# UNITED STATES PATENT AND TRADEMARK OFFICE

APPLICATION NO.	FILING DATE	FIRST NAMED INVENTOR	ATTORNEY DOCKET NO.	CONFIRMATION NO.
10/773,242	02/09/2004	Hong-Jik Doo	956-1001	7168
38209	7590	12/02/2005		
STANZIONE & KIM, LLP 919 18TH STREET, N.W. SUITE 440 WASHINGTON, DC 20006			EXAMINER WILLIAMS, KENNETH C	
			ART UNIT 3739	PAPER NUMBER

**Office Action Summary**

## DETAILED ACTION

**FIG. 6a**

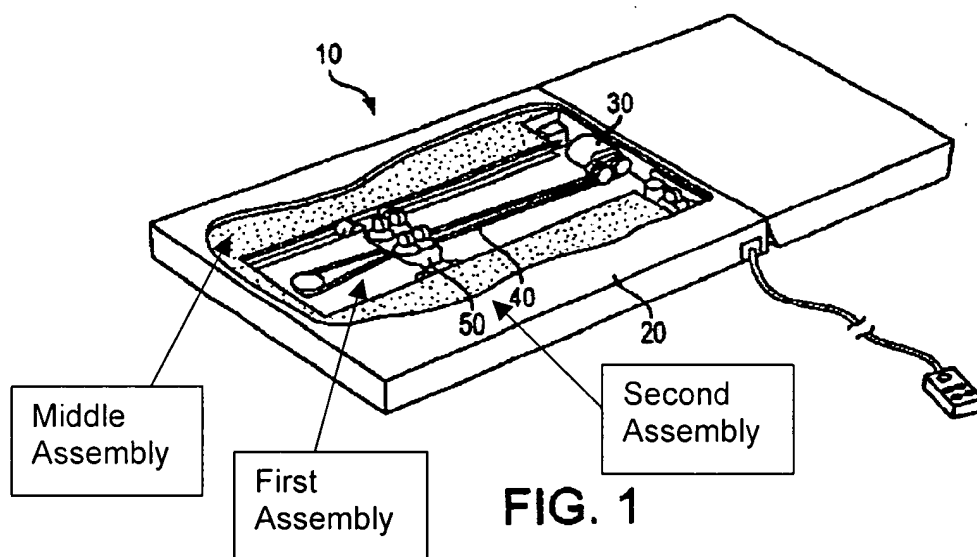
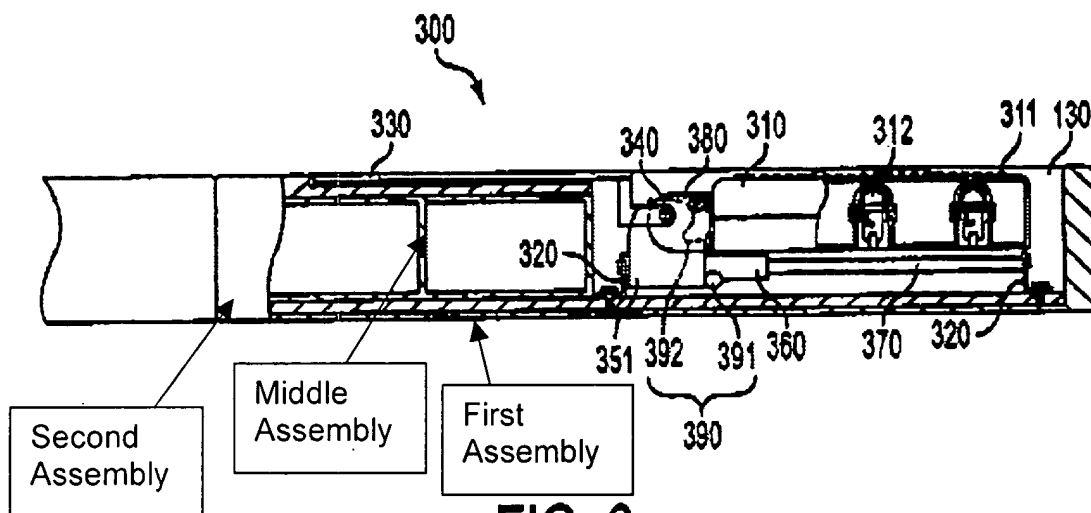
In regards to Claim 3, Kim in view of Lloyd discloses a personal thermotherapy instrument (See Claim 2 Rejection). Kim further discloses "first assemblies having a base plate", "middle assemblies each provided with electric field parts to cover the spinal corrector and the foot pressure plate" and "second assemblies combined as one body with an upper part of the middle assemblies" (See below Kim Figures 1 and 6a).

**FIG 2**

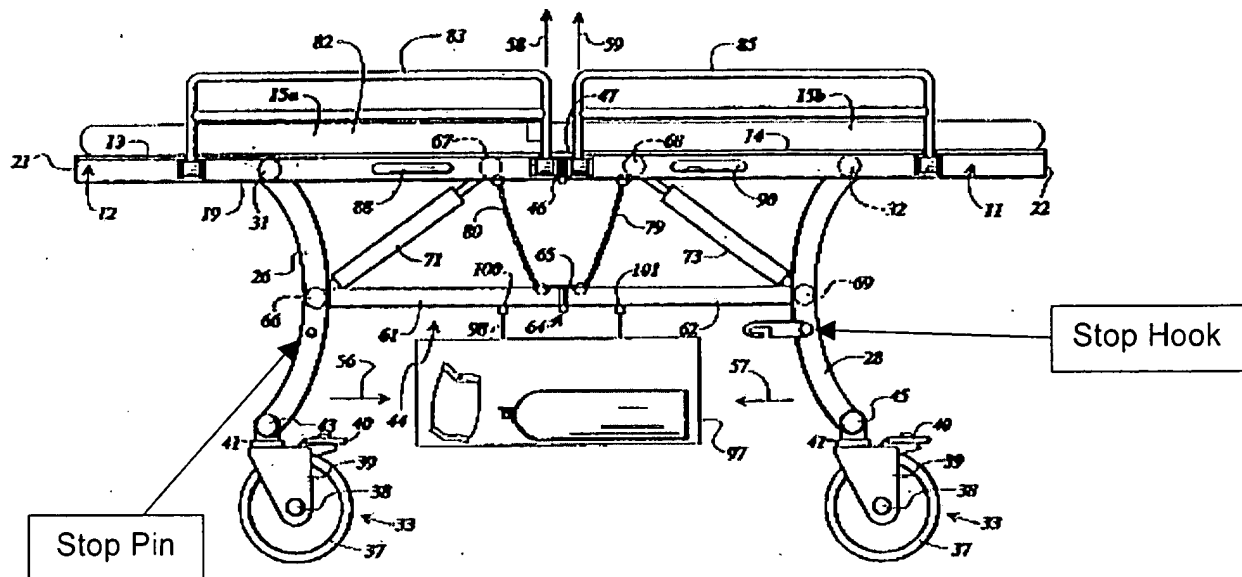
a. In regards to Claim 6, Kim in view of Lloyd discloses a thermotherapy instrument (See Claim 4 Rejection). Kim in view of Lloyd does not disclose “a stop pin” and “a stop hook”. Attention is directed to the Grant reference, which provides a pertinent solution to providing a portable therapy table, discloses a pin and hook lock on a collapsible patient bed (See below Grant Figure 2). It would have been obvious to one of ordinary skill in the art at the time of the invention to modify the device of Kim in view of Lloyd with the teaching of Grant to provide an adequate locking means to prevent unintentional unfolding the thermotherapy instrument.
